H TECHNICAL BULLETIN

PRIMAAX® EX / FIREMAAX® EX U-beam Assembly Service Kits

SUBJECT: Enhanced Support Beam Assembly

LIT NO: SEU-0228

FIGURE 1

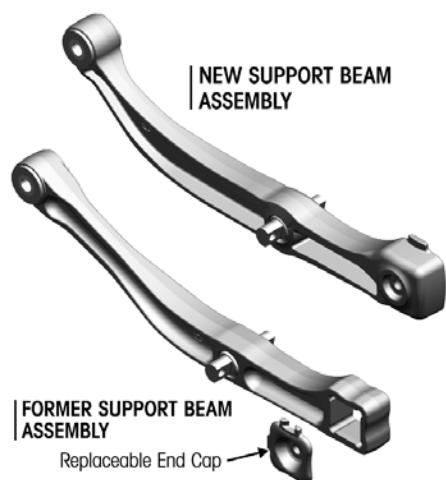
Effective March of 2009, new enhanced support beam assemblies (Part No. 66311-XXX) were phased into production with the launch of the PRIMAAX® EX and FIREMAAX® EX suspension systems. The new design of the support beam assemblies features integrated end caps and air spring retainers (see Figure 1) for fewer parts and increased durability. The new beam assemblies are intended for all approved PRIMAAX EX and FIREMAAX EX applications.

THE NEW DESIGN

- Provides greater durability in approved applications
- Remains consistent with the ride quality and stability of the original design

FIGURE 2

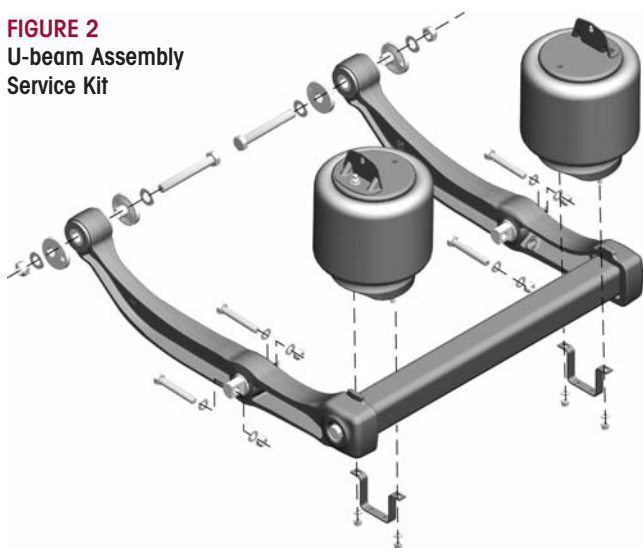
The new support beam assemblies are available in the following U-beam assembly kits for aftermarket service purposes, see chart on page 2. All PRIMAAX EX and FIREMAAX EX, as well as all prior PRIMAAX and FIREMAAX suspensions can be serviced with these kits. Each service kit is intended for servicing the associated suspension parts on one axle, and includes two support beam assemblies, one cross tube, two air spring assemblies, air spring hardware, QUIK-ALIGN® hardware and D-pin hardware, see Figure 2.

To measure length "A" Dimension properly:

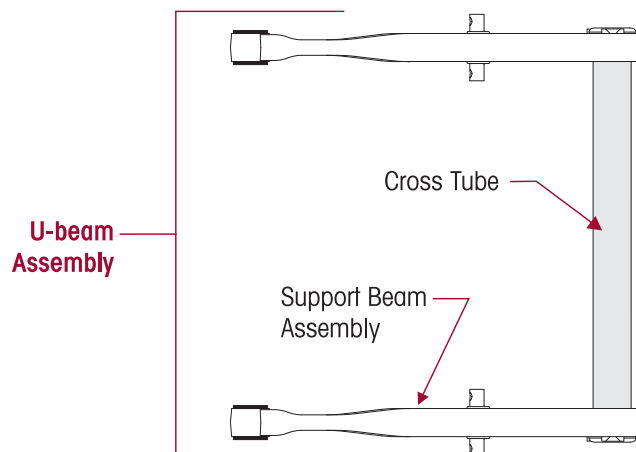
- Remove cross tube from the suspension's existing U-beam assembly.
- **End to end** measurement is needed to determine the proper U-beam assembly aftermarket service kit part number.
